AMENDMENT OF SOLICITATION/MODIFICATION OF CONTRACT				1. CONTRACT ID CODE		PAGE OF PAGES 1 30	
2. AMENDMENT/MODIFICATION NO. 0003		3. EFFECTIVE DATE 07/24/00		4. REQUISITION/PURCHASE REQ. NO.		5. PROJECT NO. (If applicable) ED-98-002

14. DESCRIPTION OF AMENDMENT/MODIFICATION (Organized by UCF section headings, including solicitation/contract subject matter where feasible.)							
The above numbered solicitation for Flood Control of the Mississippi River & Tributaries, Mississippi Delta Region, Davis Pond Freshwater Diversion Project, Contract 2B, St. Charles Parish, LA, is hereby amended as follows: <div style="text-align: center;">BID OPENING DATE</div> BID OPENING DATE & TIME OF 9 AUGUST 2000, 2:00 P.M., LOCAL TIME AT PLACE OF BID OPENING, IS HEREBY ESTABLISHED.							
Except as provided herein, all terms and conditions of the document referenced in Item 9A or 10A, as heretofore changed, remains unchanged and in full force and effect.							
15A. NAME AND TITLE OF SIGNER (Type or print)				16A. NAME AND TITLE OF CONTRACTING OFFICER (Type or print)			
15B. CONTRACTOR/OFFEROR		15C. DATE SIGNED		16B. UNITED STATES OF AMERICA		16C. DATE SIGNED

Flood Control of the Mississippi River

ELEVATIONS IN FEET - N.G.V.D.

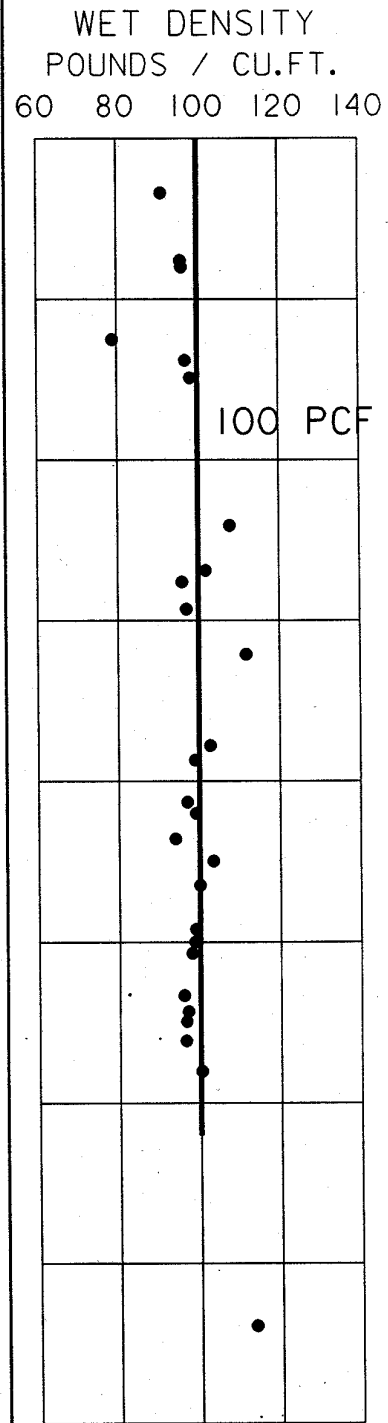
The design of the temporary retaining structures must be performed and stamped by a registered Professional Engineer. The design of the sheet pile wall shall be developed using a method of analysis indicated in paragraph 1.4.1, with the safety factor applied to the soil strengths on both sides of the wall. The soil properties used shall be those presented in the drawings and/or in the figure(s) attached at the end of this section.

A MAXIMUM PHI ANGLE OF 23 DEGREES
MAY BE USED FOR S-CASE CLAYS.
